APPLICANT'S RESPONSES TO RELEVANT REPRESENTATIONS AND ADDITIONAL SUBMISSIONS

Drax Bioenergy with Carbon Capture and Storage

Document Reference Number: 8.3

Applicant: Drax Power Limited

Ground Level Over Cross Section

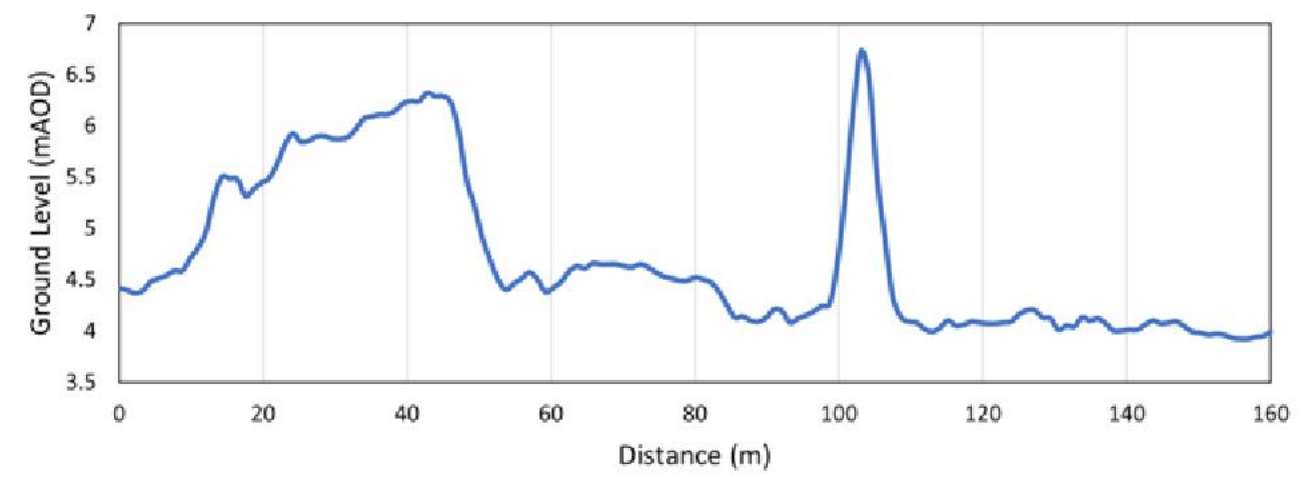
4.5	<p>Table 12.6 Surface Water Features within the study area that have the Potential to be Affected by the Proposed Scheme. Several of the ponds within this table which have a recorded presence of Great Crested Newt are not considered as 'sensitive receptor'. We disagree with this as they may be a habitat of the Great Crested Newt, which is a protected species and therefore a 'sensitive receptor'.</p>	<p>Whilst these ponds could be considered as a sensitive receptor as the presence of Great Crested Newt has been recorded / provide suitable habitat, they are not likely to be affected by the construction of the Proposed Scheme given that they are separated from the Proposed Scheme and Construction Areas, by an earth embankment, as shown in the image below, which would prevent any pollutants / contaminants which are accidentally released from the construction of the Proposed Scheme from reaching them.</p>
